parts detailed in Spares Note No.121.

THRUST PEG ASSEMBLY

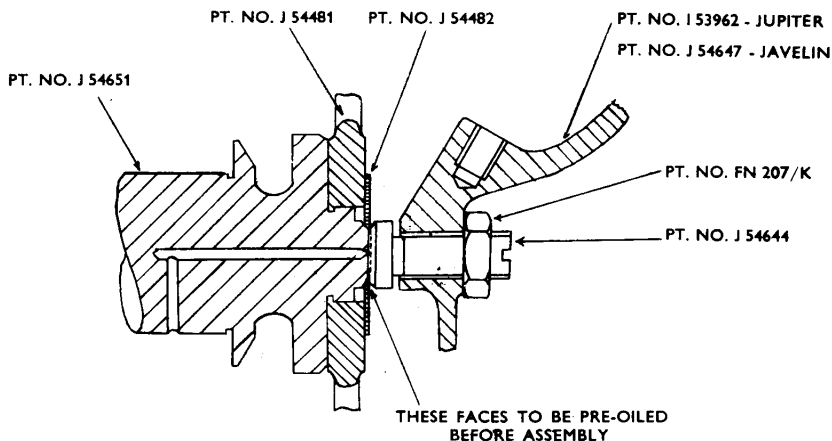
NOTE: It is most essential that the adjustment is NOT carried out with the engine running.

The bearing surface of the Camshaft and Thrust Peg must be lubricated prior to assembly.
